From: WILLIFORD Dennis (AREVA) [Dennis.Williford@areva.com]
Sent: Wednesday, May 25, 2011 3:03 PM
To: Tesfaye, Getachew
Cc: BENNETT Kathy (AREVA); DELANO Karen (AREVA); ROMINE Judy (AREVA); RYAN Tom (AREVA)
Subject: Response to U.S. EPR Design Certification Application RAI No. 442, FSAR Ch. 7, Supplement 12
Attachments: RAI 442 Supplement 12 Response US EPR DC.pdf

**QUESTIONS for Instrumentation, Controls and Electrical Engineering 1
(AP1000/EPR Projects) (ICE1)**

Question 07.03-32:

Response to Question 07.03-32:

Figure 7.3-1—~~Typical~~ESF Actuation
(Sheet 1 of 5)

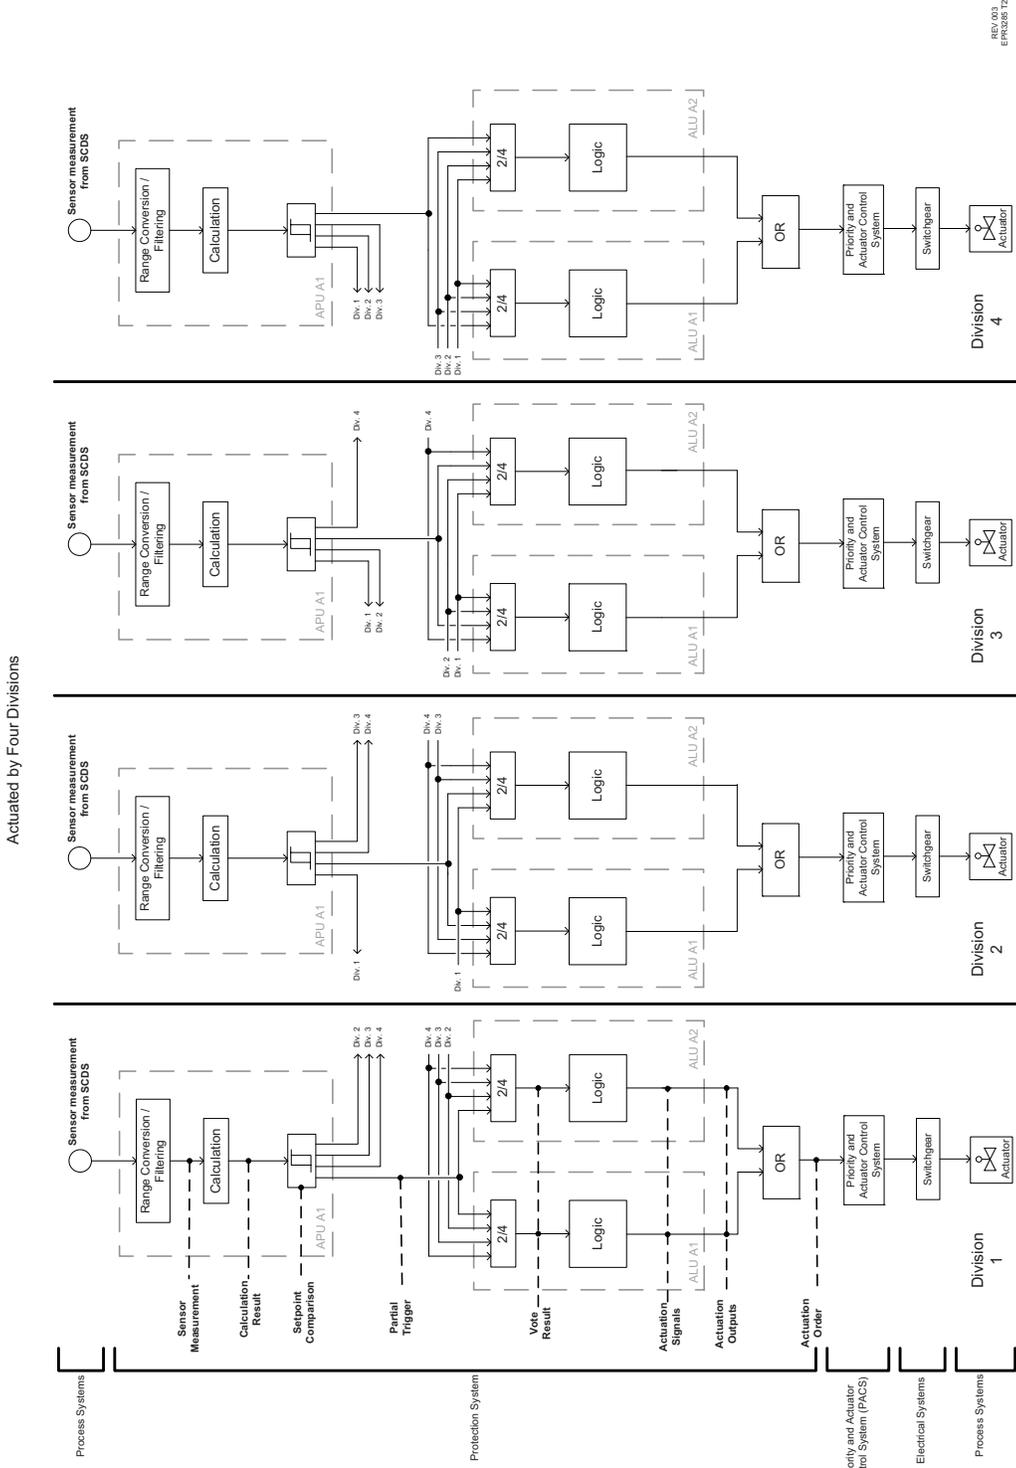
After reviewing the applicant's response to RAI 285, Question 07.03-27, the staff requests the applicant to explicitly identify in Chapter 7 which Protection System (PS) manual functions are credited in the safety analysis.

control system (PACS) for prioritization and interface to the actuators. ~~The typical~~ An example of an ESF actuation sequence performed ~~acted~~ by four divisions of the protection system PS is illustrated in Figure 7.3-1 (Sheet 1), and is described as follows:
